Improving 800GBASE-ER PCS PTP accuracy (supporting comments 254- 256, 302, 303, 356, 457, 458)

Tom Huber, Nokia

Comments 254-256, 302, 303, 457, 458

A picture is worth a thousand (or at least a slide full of) words

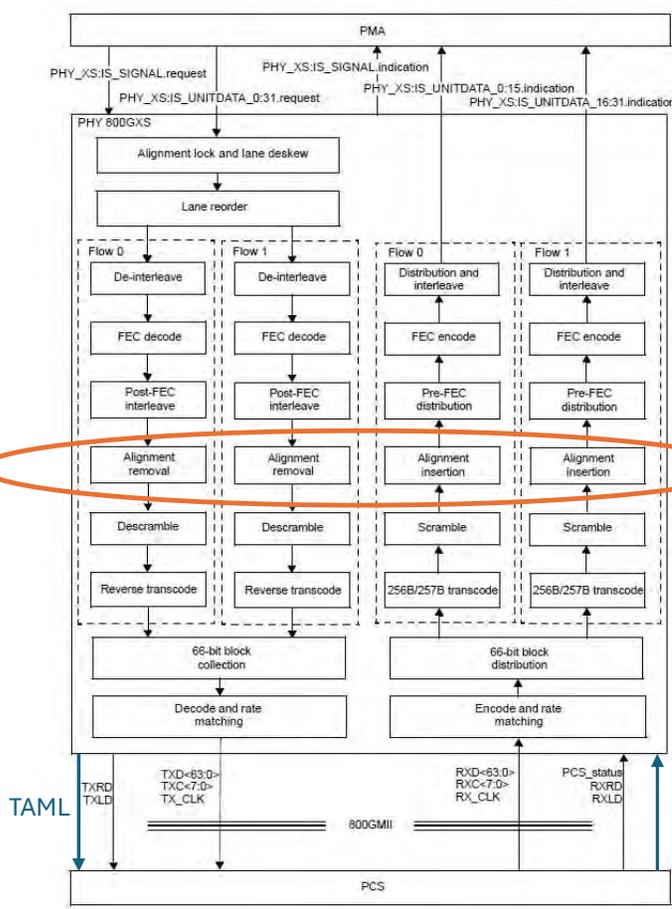
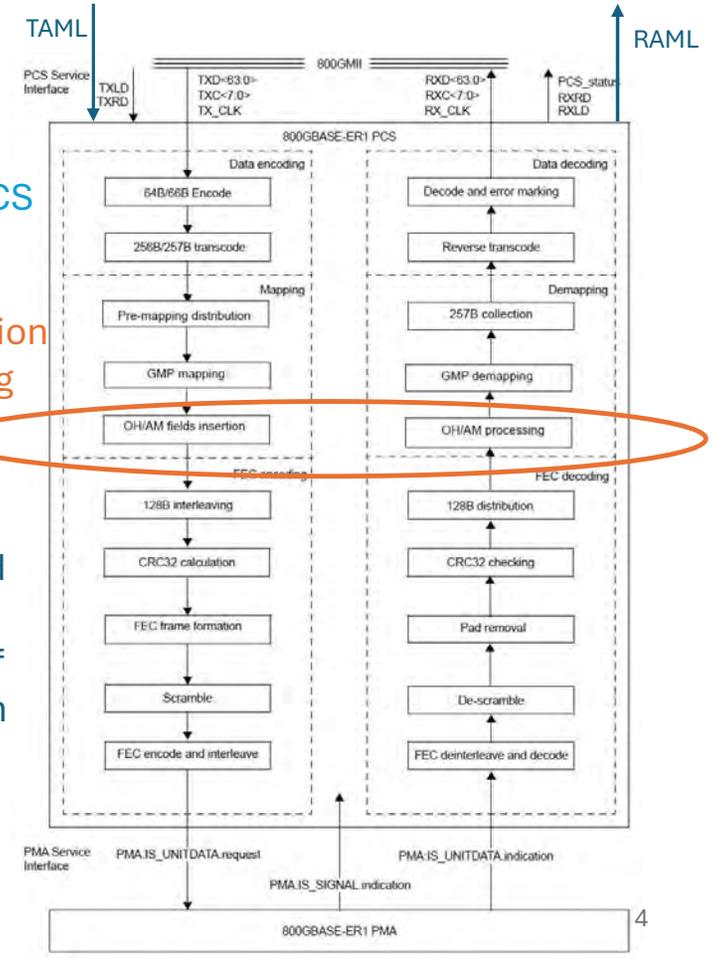
Need to define signals (TAML and RAML) between the XS and ER1 PCS to enable communication of AM location information between these functions

Transmit direction

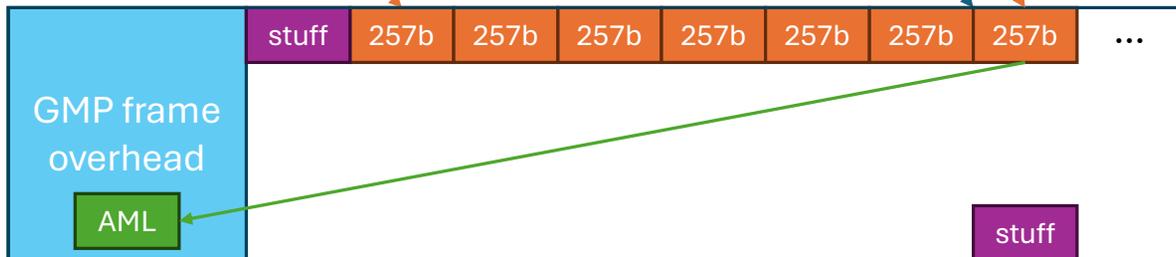
Assert TAML with the MII transaction that is associated with the first 66b block

Encode the position of the block where the AMs are supposed to go in the AML overhead (for GMP frames without AMs, AML is set to zero)

The figure shows the case where the AMs happened to precede a 66b block that was first in a 257b block. In practice this will always be the case. In theory, the 66b block could be elsewhere in the 257b block if the PHY_XS or PCS does any rate adaptation.

Receive direction

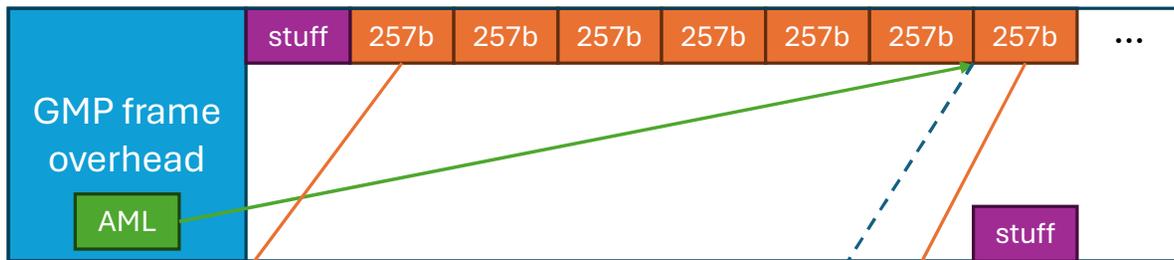
AMs are supposed to go before the first 66b block of this 257b block, so assert RAML with that MII transaction

Insert AMs before the block where RAML is asserted
